Groundwater Application Review Summary Form

Application # G- 18650

To: Kristopher Byrd, Well Construction and Compliance Section Manager
From: Joel Jeffery, Well Construction Program Coordinator
Subject: Review of Water Right Application G-18650
Date: November 26, 2018

TO: Water Rights Section Date 11/20/2018
 FROM: Groundwater Section Travis Brown and Dennis Orłowski
 Reviewer's Name
 SUBJECT: Application G- 18650 Supersedes review of _____
 Date of Review(s)

Stream Depletion Analysis Results (SW1)

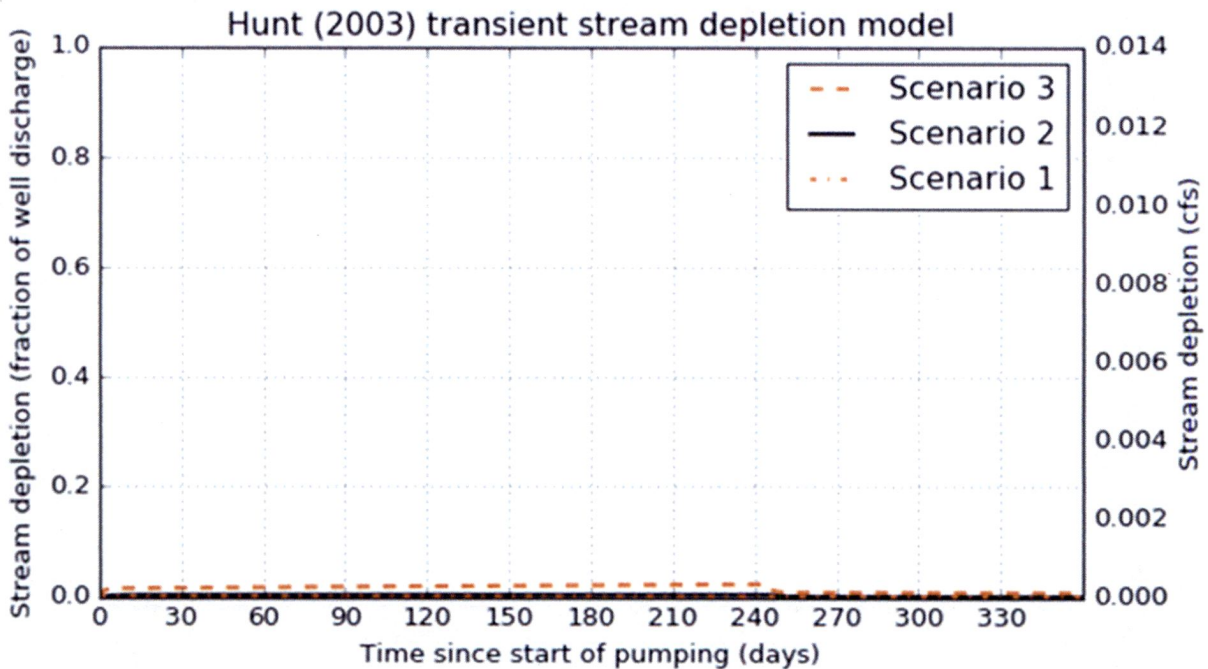
Comments: C3a: Potential depletion of SW1 (unnamed tributary to the South Yamhill River) was estimated using the Hunt 2003 analytical stream depletion model (Hunt, 2003). Hydraulic parameters used for the model are derived either from regional data or studies of the hydrogeologic regime (OWRD Well Log Query Report; Conlon et al, 2003, 2005; Iverson, 2002; Woodward et al, 1998) or are within a typical range of values for the parameter within the hydrogeologic regime (Freeze and Cherry, 1979; Domenico and Mifflin, 1965). See attached "Stream Depletion Analysis Results (SW1)" for the specific parameters used in the analysis.

The Hunt 2003 analytical model results indicate that depletion of SW1 is anticipated to be less than 1% of the well discharge after 30 days of pumping.

C3a (690-09-040(4)): The Hunt 2003 analytical model results indicate that depletion of SW1 is expected to be substantially less than 1% of the well discharge after 30 days of continuous pumping.

Stream Depletion Analysis Results (SW2)

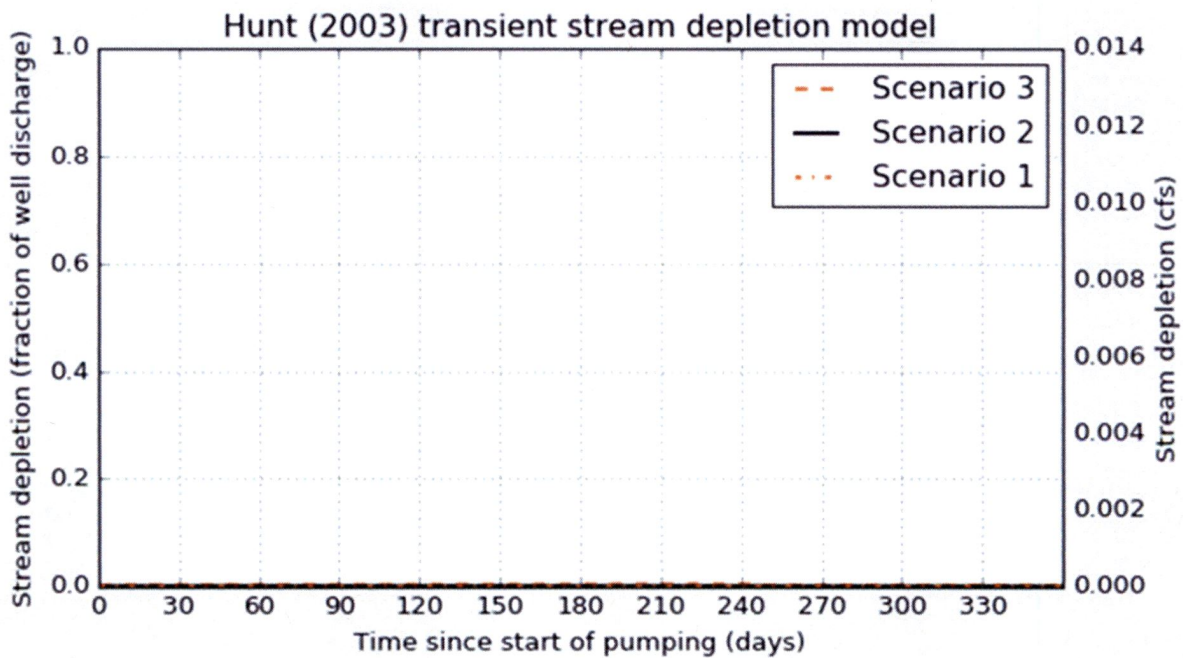
C4a: Potential depletion of SW2 (Unnamed tributary to Salt Creek) was estimated using Hunt 2003 analytical stream depletion model (Hunt, 2003). Hydraulic parameters used for the model are derived either from regional data or studies of the hydrogeologic regime (OWRD Well Log Query Report; Conlon et al, 2003, 2005; Iverson, 2002; Woodward et al, 1998) or are

within a typical range of values for the parameter within the hydrogeologic regime (Freeze and Cherry, 1979; Domenico and Mifflin, 1965). See attached "Stream Depletion Analysis Results (SW2)" for the specific parameters used in the analysis.

The Hunt 2003 analytical modeling results indicate that depletion of SW1 is expected to be negligible one year after the start of pumping for Well 1 as proposed in the application.

C4a (690-09-040(5)): The Hunt 2003 analytical model results indicate that depletion of SW2 is expected to be negligible within one year of the start of pumping of Well 1 as proposed in the application.
